DEPARTMENT OF TRANSPORTATION**Federal Aviation Administration****14 CFR Part 39**

[Docket No. FAA–2024–0237; Project Identifier AD–2023–00491–R; Amendment 39–22853; AD 2024–19–11]

Airworthiness Directives; Robinson Helicopter Company Helicopters

ACTION: Final rule.

Figure 1 to Paragraph (g)(1)(i)—Flex Plate Inspection

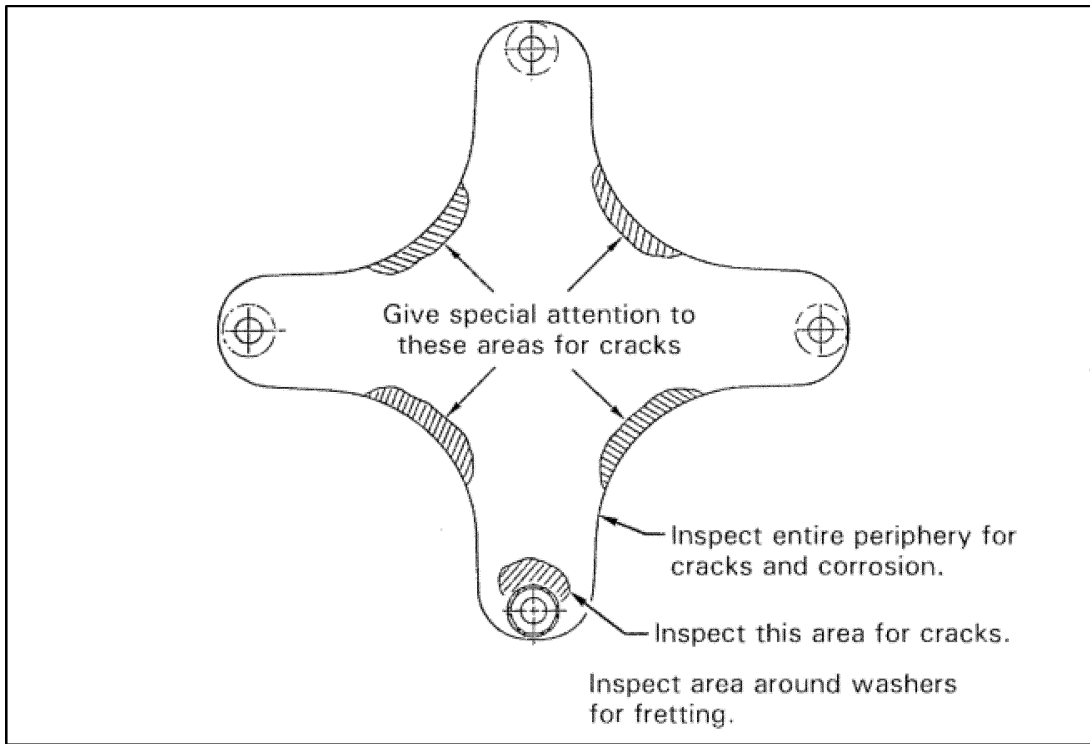
(i) Visually inspect forward flex plate assembly (flex plate) part number (P/N) C947-1 for any loose fasteners, cracks, fretting, corrosion, wear, and to ensure that the washers are bonded to both sides of each flex plate arm, in the areas depicted in Figure 1 to paragraph (g)(1)(i) of this AD. If there is any loose fastener (can be moved by hand), crack, fretting, corrosion, or wear that consists of the washers not securely bonded to both sides of each flex plate arm, before further flight, remove the flex plate from service and replace with an airworthy flex plate.
